# **DEVELOPMENT APPLICATION ASSESSMENT REPORT**

Application Number:	DA2018/1078
Responsible Officer:	Renee Ezzy
Land to be developed (Address):	Lot 11 DP 21872, 76 Prince Charles Road FRENCHS FOREST NSW 2086
Proposed Development:	Demolition works and the construction of a seniors housing development
Zoning:	Warringah LEP2011 - Land zoned R2 Low Density Residential
Development Permissible:	Yes, under SEPP Housing for Seniors or People with a Disability
Existing Use Rights:	No
Consent Authority:	Northern Beaches Council
Land and Environment Court Action:	No
Owner:	Khosrow Ataii Mojgan Ataii
Applicant:	Khosrow Ataii
Application lodged:	25/06/2018
Integrated Development:	No
Designated Development:	No
State Reporting Category:	Residential - Seniors Living
Notified:	04/07/2018 to 22/07/2018
Advertised:	Not Advertised
Submissions Received:	1
Recommendation:	Approval
Estimated Cost of Works:	\$ 1,750,000.00

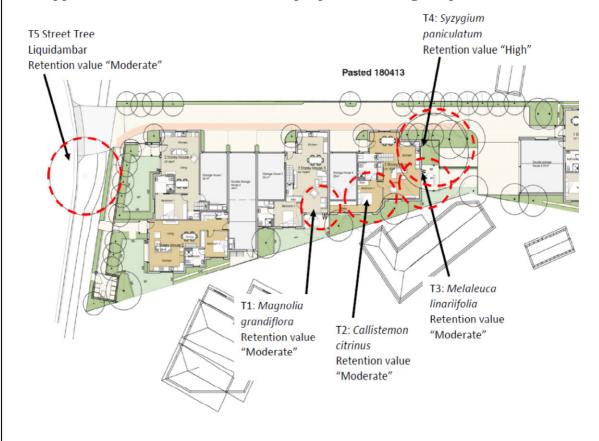
7.1.1 The supplied plans will necessitate the removal of four (4) trees construction impact. Trees T1, T2 & T3 all fall within the envelope be retained given the extent, close offset distance of construction

7.1.2 T5 Liquidambar Styraciflua (Street tree) under the current des excavation for driveway is within the SRZ and will necessitate structural roots all on the northern side of the trunk and the removed the proposed driveway equating to approximate 25% of the overall naddition, the Bin bay is within Tree Protection Zone (TPZ) but of stormwater ingress pits (trenching) further impacts the tree's TPZ
